RE: JMC Project 20101  
The Summit Club at Armonk-Residential Phase  
Bedford Road (Route 22)  
Town of North Castle, NY

**Response to Site Plan, Steep Slopes and Tree Removal Approval Resolution Conditions**

The revisions depicted on the above noted plans reflect responses to conditions outlined in the Draft Town of North Castle Site Plan, Steep Slopes and Tree Removal Approval Resolution, dated July 10, 2023. For ease of review, we have repeated and enumerated the conditions in italic print, followed by our responses:

**SITE GRADING PLAN (NORTH)**  
**THE SUMMIT CLUB AT ARMONK (RESIDENTIAL PHASE)**  
568 & 570 BEDFORD ROAD (NY-22)  
TOWN OF NORTH CASTLE, NEW YORK

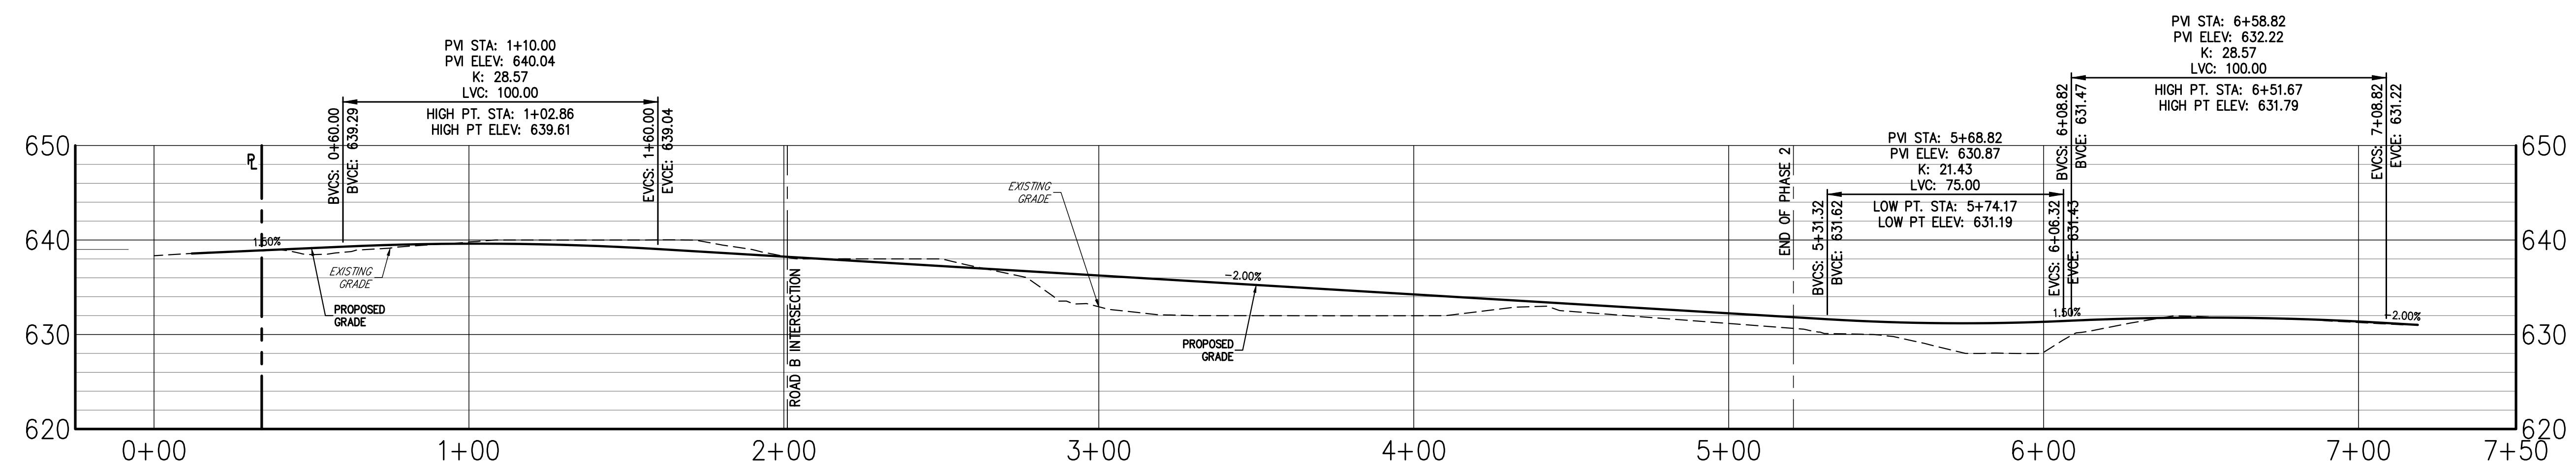
Response No. 5

A cut and fill analysis for each phase of construction has been prepared and summarized in a table on JMC drawing C-200 "Site Grading Plan (South)", last revised 07/24/2023 and JMC drawing C-201 "Site Grading Plan (North)", last revised 07/24/2023.

3 CONCRETE SIDEWALK DETAIL

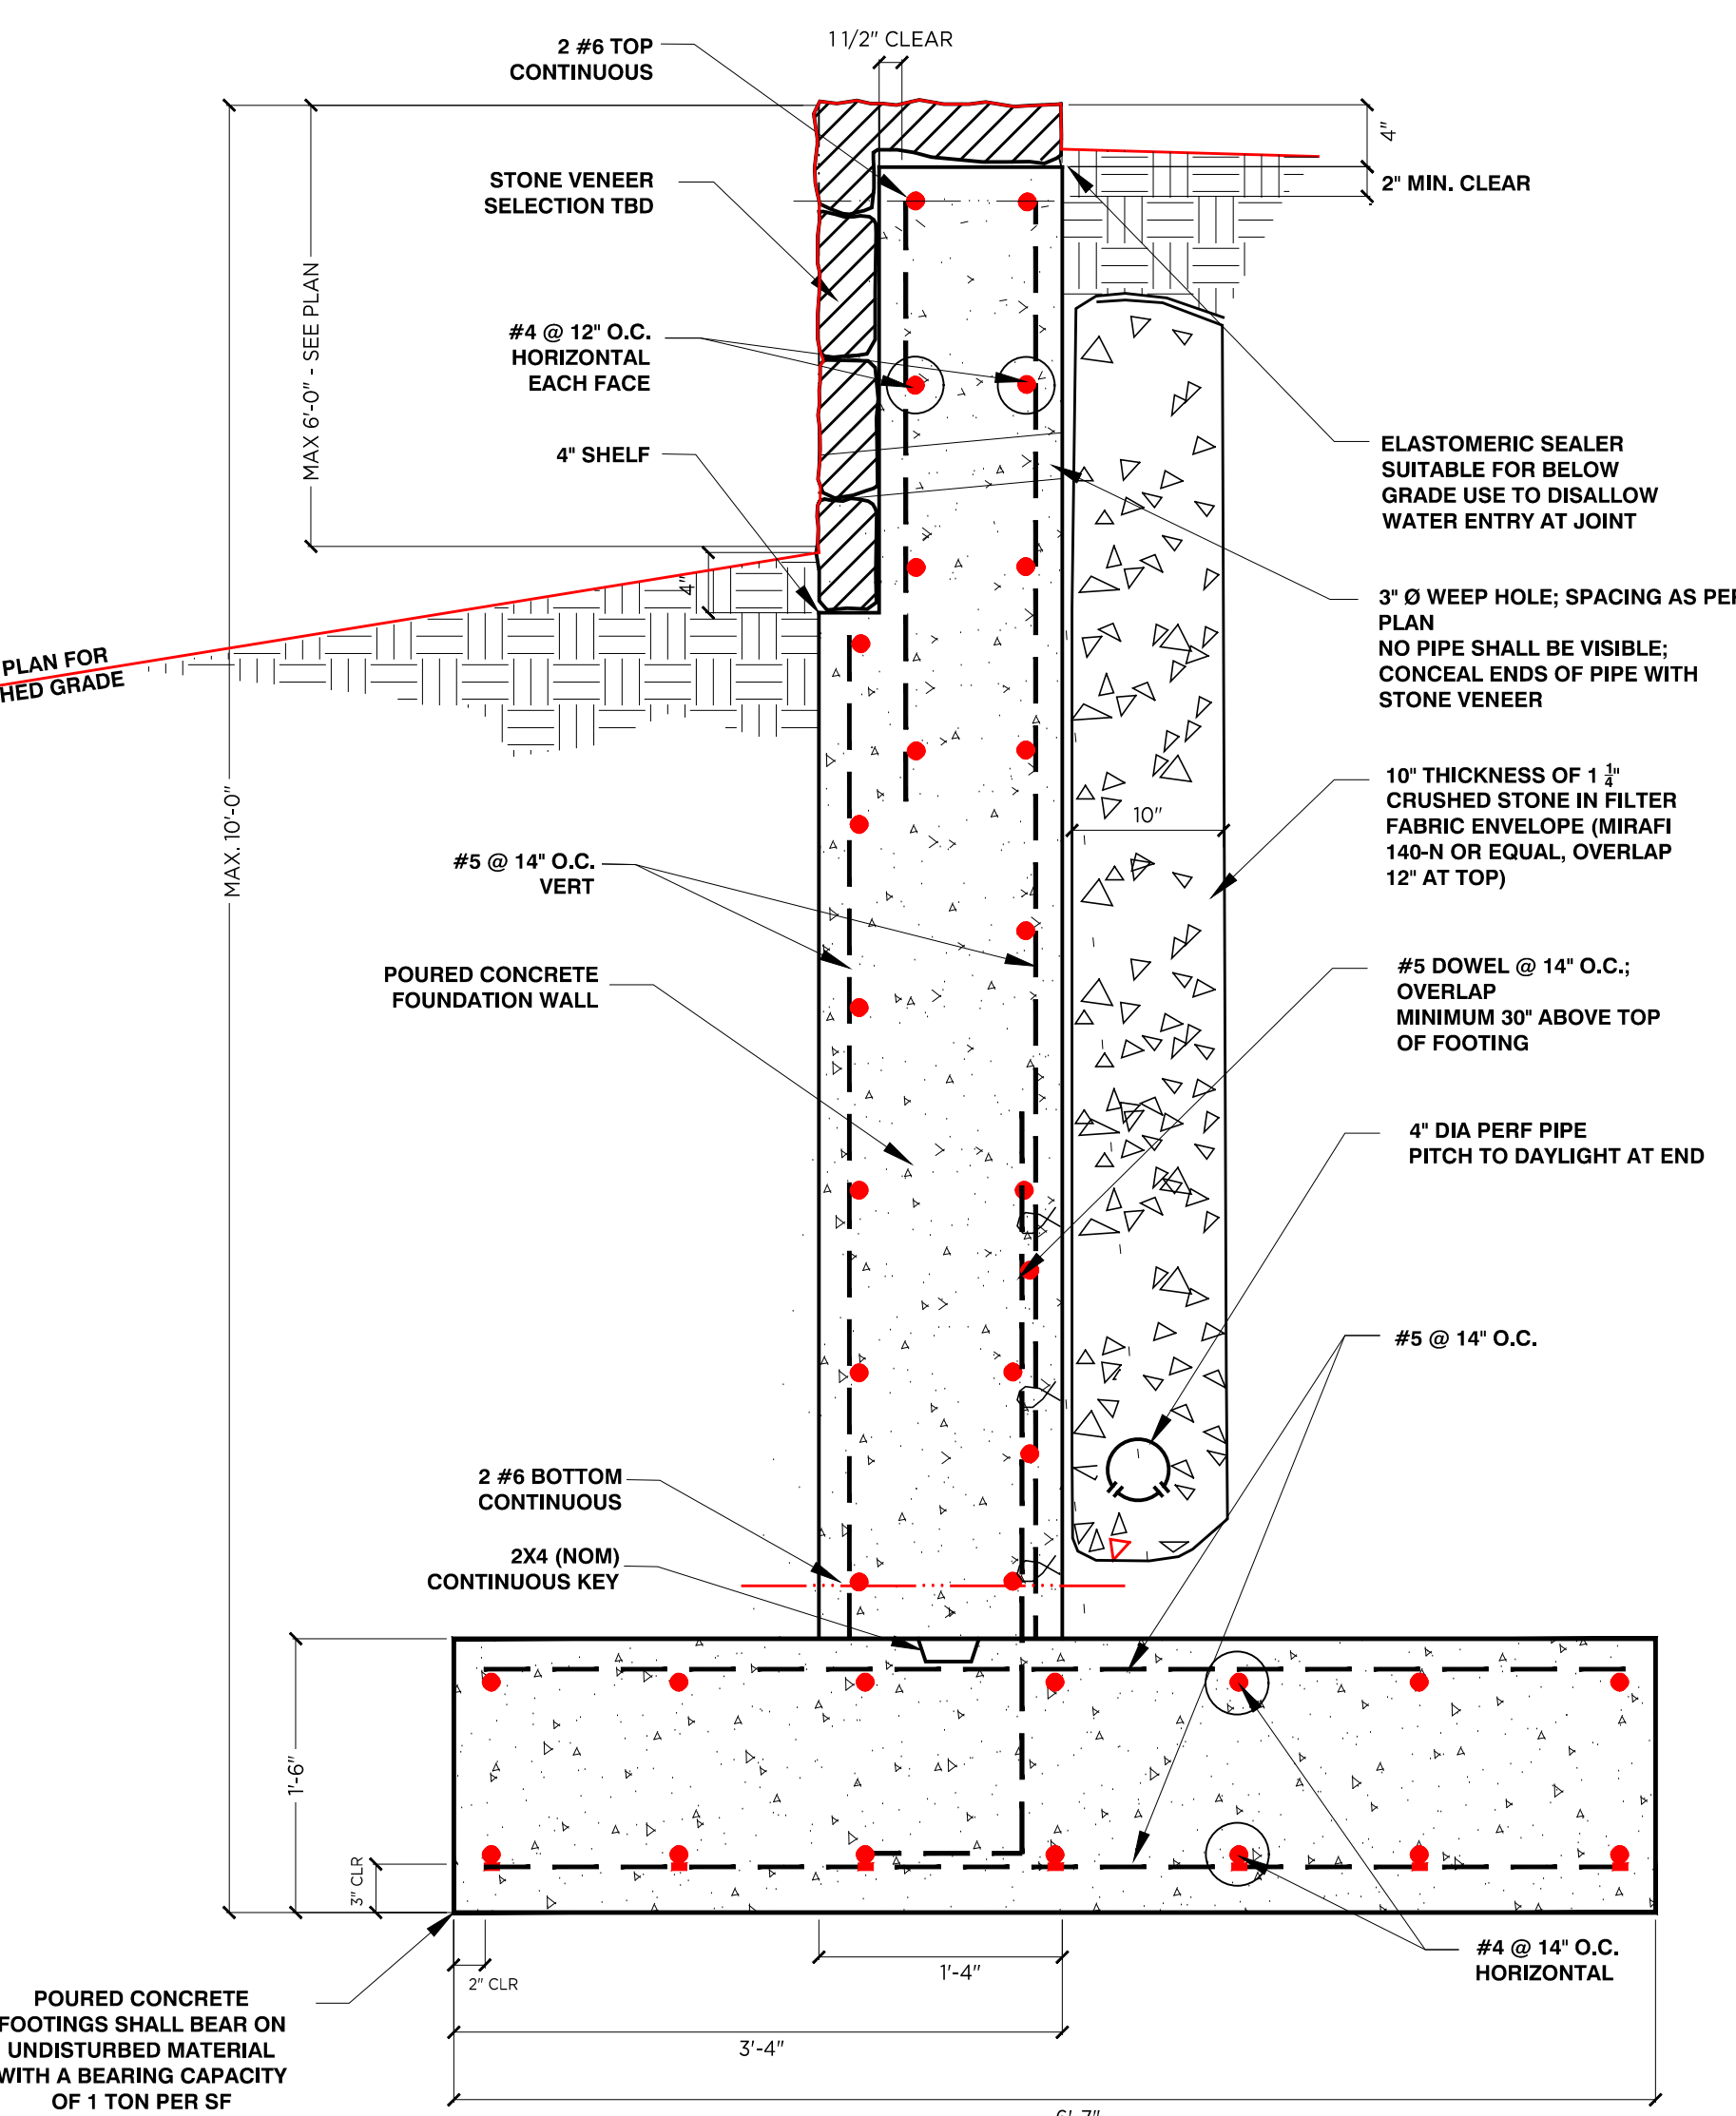
*Revise note on concrete sidewalk detail to reflect 5” minimum thickness to the satisfaction of the Town Engineer.*

The concrete sidewalk detail has been revised to depict a 5” minimum thickness.
